**Department of Energy**  
Carlsbad Field Office  
P. O. Box 3090  
Carlsbad, New Mexico 88221  
September 29, 2017

**Subject:** Planned Change Notice Regarding the Excavation and Construction of a New Ventilation Shaft and Associated Access Drifts at the Waste Isolation Pilot Plant

**Impact Assessment of an Additional WIPP Shaft**

PLANNED DRIFTS TO CONNECT THE NEW SHAFT TO THE REPOSITORY

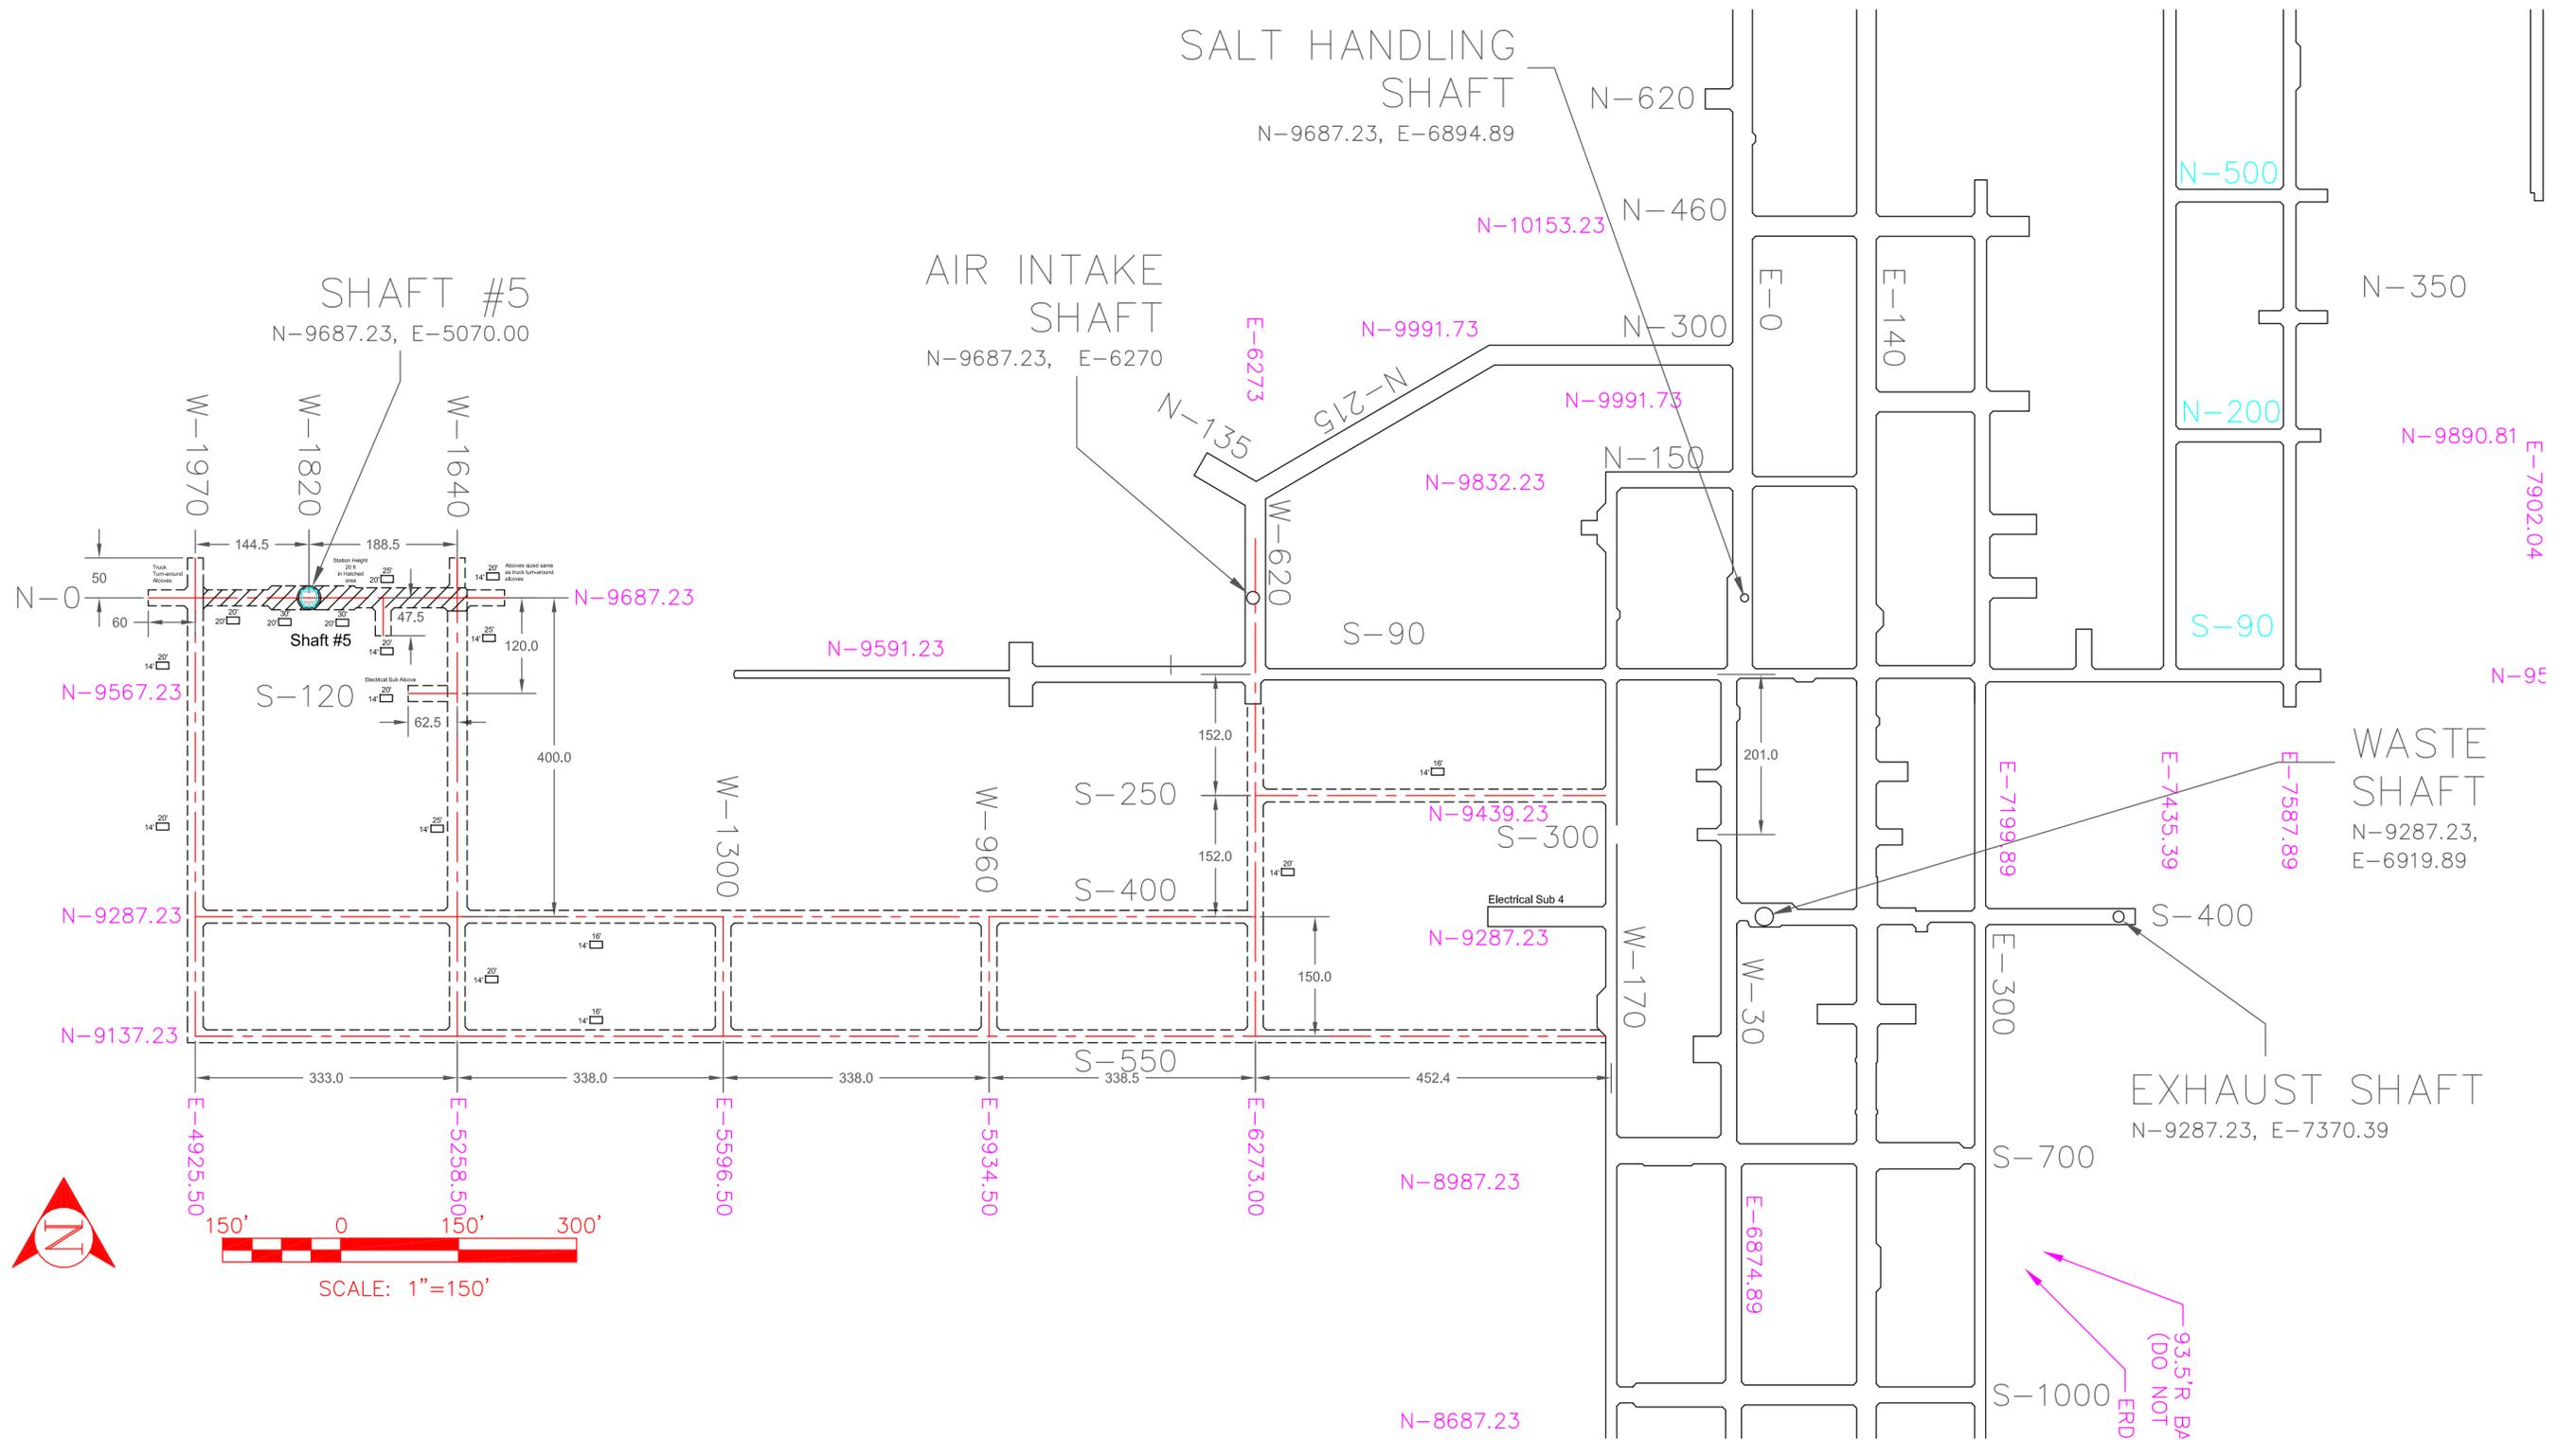
The purpose of this letter is to notify you of the plan to add a new ventilation shaft (shaft #5) and associated access drifts to the underground facility at the Waste Isolation Pilot Plant (WIPP). These changes are needed to provide additional ventilation in the underground facility.

Shaft #5 (S#5) will be located nominally 1,200 feet west of the existing Air Intake Shaft (AIS). Surface-mounted fans are planned for downcasting air into the underground via S#5. The air from S#5 will primarily be used to ventilate the Construction and Disposal Circuits through the new connecting drifts. Exhaust air, from the North, Disposal, and Waste Shaft Station Circuits, is planned to be exhausted through the existing Exhaust Shaft. Exhaust air from the Construction Circuit is planned to be routed through the existing AIS. Enclosure 1 depicts the surface location of S#5 and provides the conceptual drawings of S#5 and associated drifts. Excavation of the new shaft will occur to the northwest of the existing underground disposal area, approximately 1,970 feet from the West-170 access main and 2,000 feet from the nearest point in Panel 7. The new access drifts are located approximately 1,200 feet from the closest points in Panel 8.

Conceptual Drawing Only  
 Dashed lines are proposed drifts  
 Solid lines are existing drifts  
 Dimensions are nominal

Figure 2-2: The BRAGFLO Repository Representation used in the Exhaust Shaft Impact Assessment

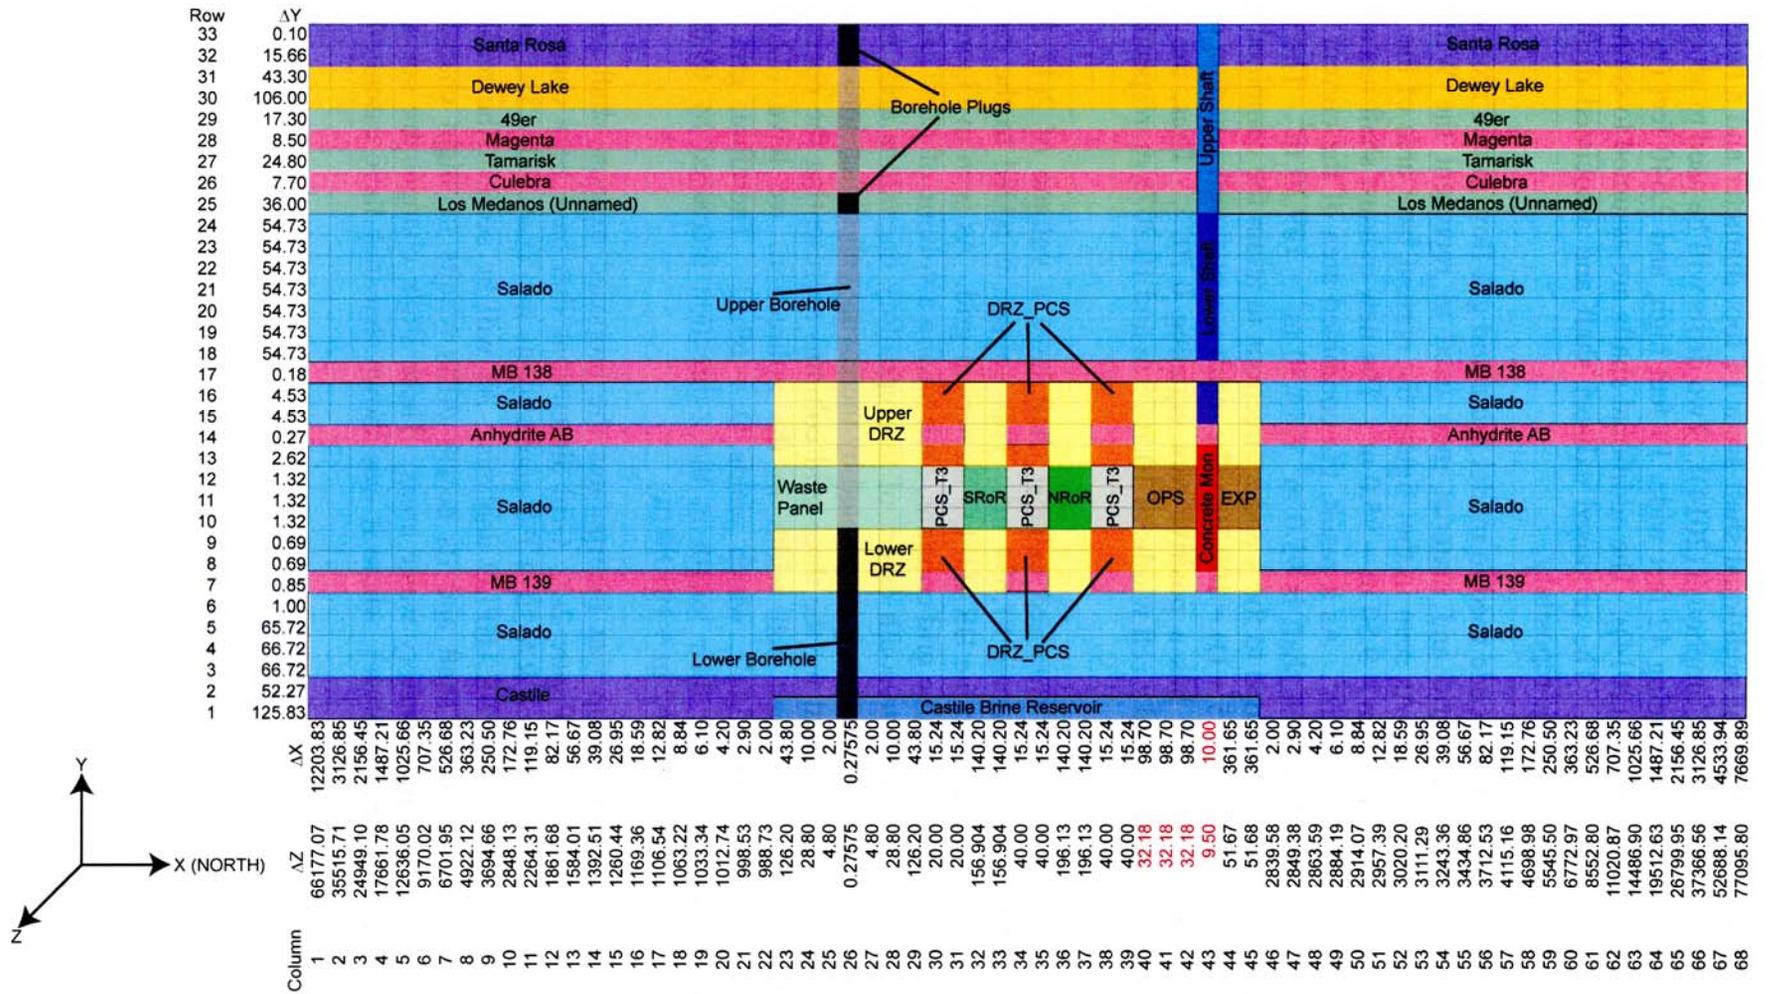
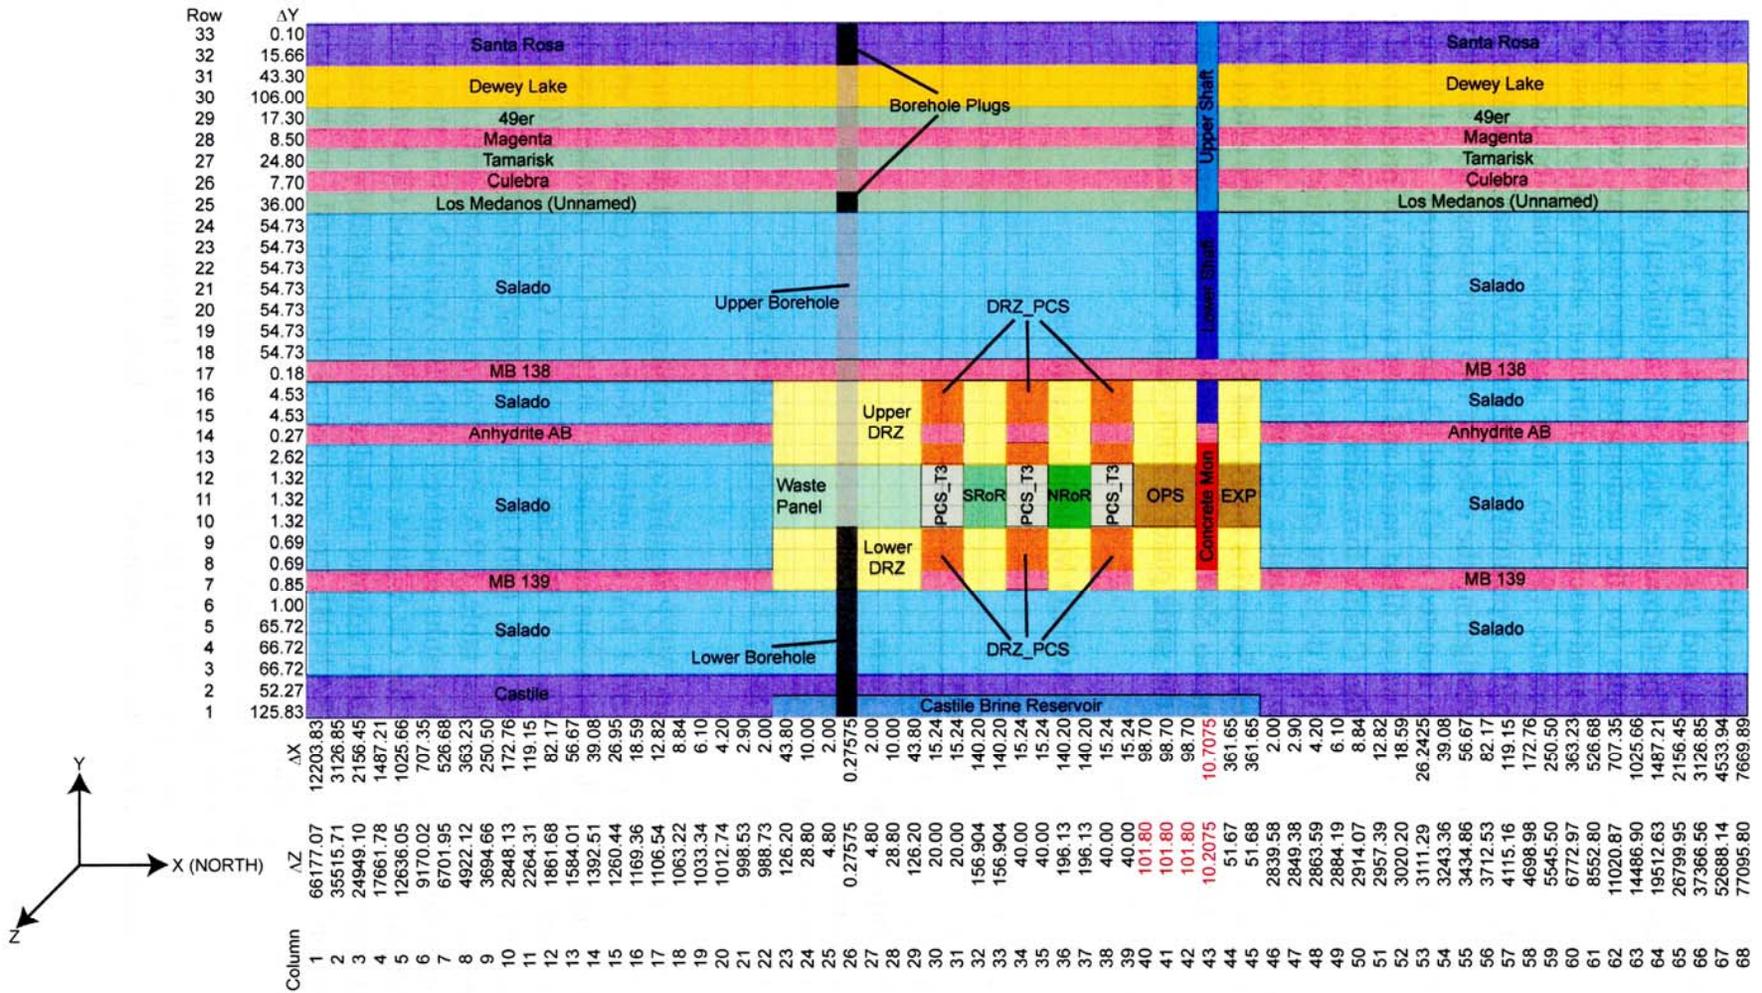
The code BRAGFLO is the WIPP PA code used to model brine and gas flow in and around the repository. The current numerical grid and material map used to represent the WIPP in BRAGFLO are shown in Figure 2-1. As seen in that figure, the current base area of the shaft representation in BRAGFLO is  $10.00 \text{ m} \times 9.50 \text{ m} = 95.0 \text{ m}^2$ . The new exhaust shaft has a base area of  $\pi (7 \text{ ft})^2 = 153.94 \text{ ft}^2 = 14.30 \text{ m}^2$ . As a result, the combined area of the current shaft representation and the proposed exhaust shaft is  $95.0 \text{ m}^2 + 14.30 \text{ m}^2 = 109.30 \text{ m}^2$ . The same increase in length, denoted by D, is added to the x and z directions to attain the combined base area of all five shafts, i.e.  $(10.0 + D)(9.5 + D) = 109.30$ . The result is a quadratic equation of the form  $D^2 + 19.5D - 14.3 = 0$ , which has a positive root equaling 0.7075. Thus, the shaft representation is modified to have x and z cell widths of 10.7075 m and 10.2075 m, respectively, for the analysis undertaken herein.

The two drifts corresponding to the proposed exhaust shaft have a volume of  $2(42 \text{ ft})(13 \text{ ft})(2,640 \text{ ft}) = 2,882,880 \text{ ft}^3$ , which equals  $81,634 \text{ m}^3$ . This volume is added to the current representation of the operations area in the BRAGFLO numerical grid. As seen in Figure 2-1, the operations area is represented by three grid columns, each having a volume of  $12,577.62 \text{ m}^3$ . The new drifts do not alter the north-to-south extent of the repository operations area, nor its height. As a result, the increased volume is incorporated by increasing cell dimensions in the z-direction, with the increase being equal for the three grid columns representing the operations area. With D denoting the increased cell width in the z-direction, we have  $(32.18 + D)(98.70)(3.96) = 12,577.62 + (81,634)/3$ , which yields  $D = 69.62$ . Therefore, grid cells representing the operations area have their length in the z-direction increased by 69.62 m, yielding a total length of  $32.18 \text{ m} + 69.62 \text{ m} = 101.80 \text{ m}$ .

The BRAGFLO grid and material map that incorporates the proposed exhaust shaft and its associated access drifts are shown in Figure 2-2. Grid dimensions that have been changed in Figure 2-2 are in red font, as are their CRA-2014 PA counterparts in Figure 2-1. The impact assessment done herein consists of a BRAGFLO analysis. As will be seen in the results to follow, the addition of the proposed shaft and its access drifts results in slight changes to pressures and brine saturations in repository waste areas. These slight changes are not unlike those that have been seen in prior analyses, where it was shown that they have essentially no impact on regulatory compliance.
